Access Compliance Report Public Rights-of-Way (Curb Ramps)

Main Street: **FOOTHILL_BLV** Cross Street: **ORANGE_KNOLL_DR** Location: **S**

ADA ID: **RPRK211013172329** Ramp Type: **Type 4 - Parallel** Initial Pass/Fail: **Pass** Overall Compliance: **No** Severity Score: **5**

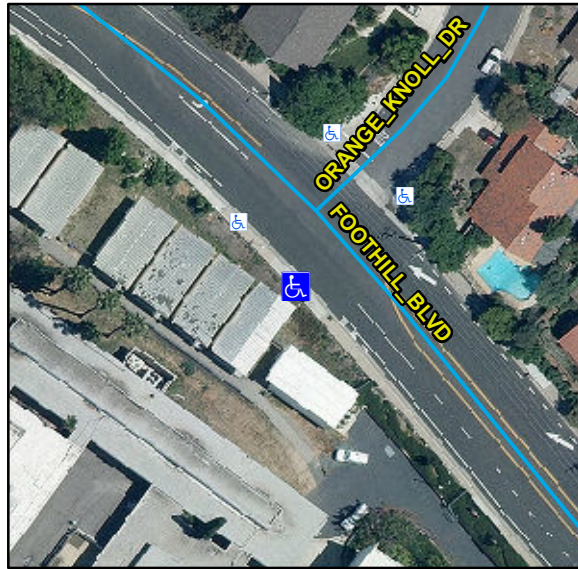
**Remove & Replace Detectable Warning System.
Gutter Ponding Observed.**
